**Project Name: Artspark Lofts**

Subject: WATER AND WASTEWATER CAPACITY AVAILABILITY LETTER

Artspark Lofts – DRC Case No. UDP-S22029 407 N Andrews Avenue, Fort Lauderdale, FL 33301

# City of Fort Lauderdale Public Works Department Water and Wastewater Capacity Analysis

Figure 1. City Water Atlas

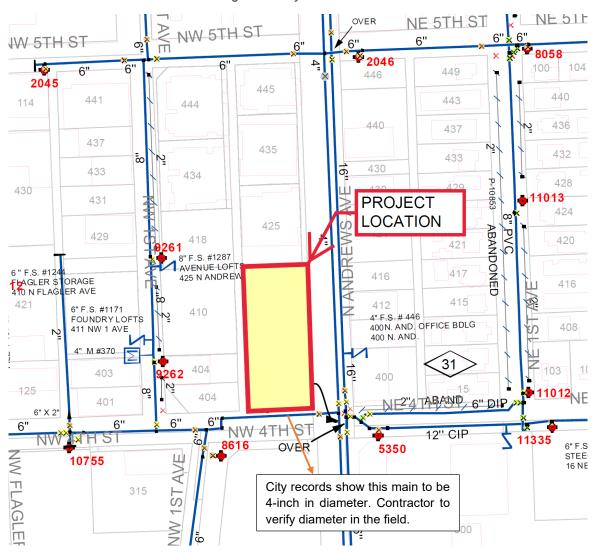
**Water:** The project currently proposes to utilize the 16-inch water main along North Andrews Avenue for water service and fire hydrant connections. Water design standards deem water mains of 16-inch in diameter and greater to be transmission lines and not appropriate for water service connections. The current utilities available to the project for service connections are the 4-inch water main along North Andrews Avenue and the 4-inch water main along NW 4<sup>th</sup> Street. Neither line would be suitable for the installation of a fire hydrant as proposed in the water and sewer plans. The City atlas, as shown on Figure 1, depicts the main along NW 4 Street as a 6-inch pipe, however field notes state that the water main is at least partially a 4-inch main. Pipe dimensions should be verified in the field. The hydraulic analysis for this project's proposed demand and fire flow requirements was completed using the 4-inch water main along North Andrews Ave and the existing fire hydrants along NW 4<sup>th</sup> Street.

**Evaluation of impact on existing distribution system:** The project proposes to utilize the 4-inch water main along North Andrews Ave. The InfoWater hydraulic model was analyzed to determine the impact of the additional demand and fire flow requirements for this project on the water distributions system. The hydraulic simulations were completed utilizing the 4-inch water main along North Andrews Avenue and the existing fire hydrants along NW 4<sup>th</sup> Street. The existing water infrastructure has the capacity to support the proposed development.

Figure 2. City Sewer Atlas

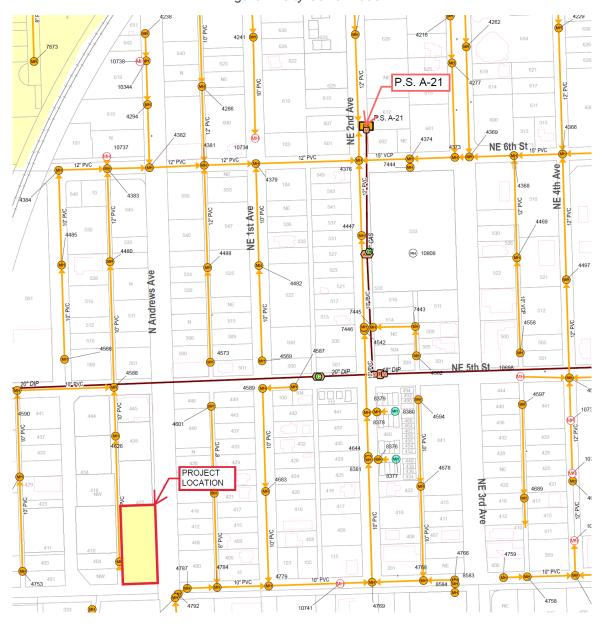
**Wastewater:** The site is currently served by a 10-inch gravity sewer main along the alley to the west of the project as shown on Figure 2.

**Evaluation of impact on existing collection system:** According to the site plan, the applicant is proposing to utilize the 10-inch gravity sewer main located along the alleyway west of the project site. Accounting for existing flows and based on the tools and information available to the City staff, it has been calculated that the pipes downstream of the proposed development will flow less than the City's governance plan threshold of 70% during peak flows. The gravity sewer downstream of the development is adequate to serve the project.

Figure 3. Water Treatment Capacity

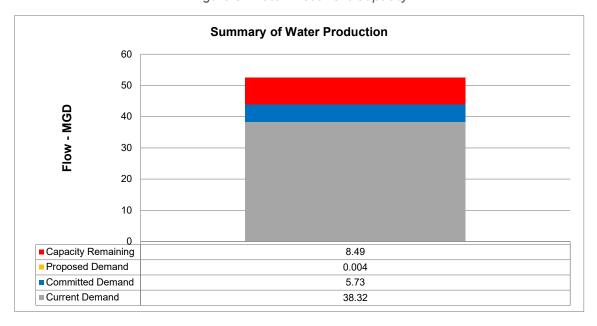
**Evaluation of impact of Permitted Water Plant Capacity:** The Fiveash and the Peele Dixie Water Treatment Plants are designed to treat 70 MGD and 12 MGD of raw water respectively (82 MGD total). The total permitted Biscayne aquifer water withdrawals for these plants is limited to 52.55 MGD per the South Florida Water Management District (SFWMD) permit number 06-00123-W.

The current twelve-month rolling average production at the two plants is 38.21 MGD. The previously committed demand from development projects in the permitting or the construction stage is 5.48 MGD. Combining these figures with the demand from the proposed project of 0.0037 MGD, the required production would be 43.70 MGD. This is less than the allowable withdrawal limit of 52.55 MGD. Therefore, the water plants have sufficient capacity to serve this project. See Figure 3 below.

Recommended Water Infrastructure Improvements: No improvements required.

Figure 4. Pump Station A-21 Nominal Average Pump Operating Time (NAPOT)

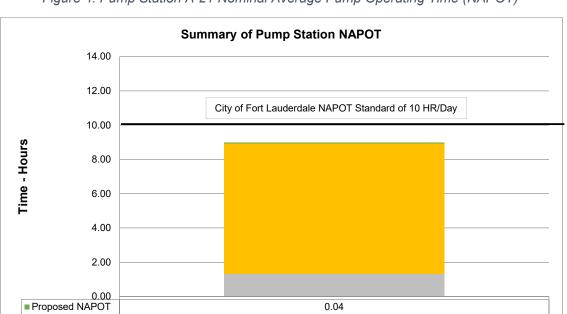
**Evaluation of impact on pumping station:** PS A-21 has a duty point of 1200 gallons per minute (GPM) and has a Nominal Average Pump Operating Time (NAPOT) of approximately 1.33 hours per day. Based on projected sewage flows, the pump run times would increase approximately 2 minute per day. Additionally, there are other committed flows from proposed developments within the PS A-21 basin resulting in 1012.55 minutes of additional runtime. PS A-21 will have a NAPOT of 18.24 hours once the proposed developments are complete, less than the recommended average of 10 hours per day. See Figure 4 below.

Recommended Wastewater Infrastructure Improvements: No improvements required.

Figure 5. Wastewater Treatment Capacity

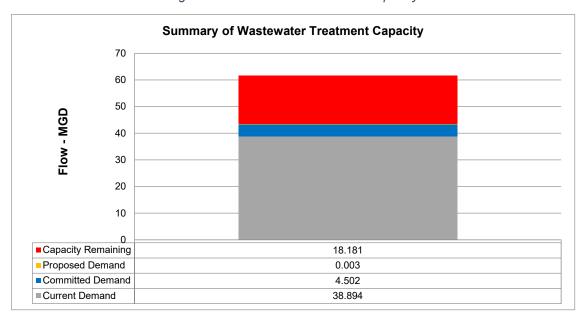
**Evaluation of impact of Permitted Wastewater Plant Capacity:** The City of Fort Lauderdale owns and operates the George T. Lohmeyer Regional Wastewater Treatment Plant (GTL), which provides wastewater treatment for the City of Fort Lauderdale. The Broward County's Environmental Protection and Growth Management Department's (EPGMD) Environmental Licensing & Building Permitting Division's licensed capacity for GTL is 48 MGD-AADF (Million Gallons per Day – Annual Average Daily Flow). The annual average daily flow (AADF) to the plant is 38.89 MGD. Combining the committed flows for previously approved projects of 4.70 MGD plus the 0.0026 MGD net contribution from the project results in a total projected flow of 43.60 MGD. This is less than the permitted treatment plant capacity of 48 MGD. Therefore, the treatment plant has sufficient capacity to serve this project. See Figure 5 below.
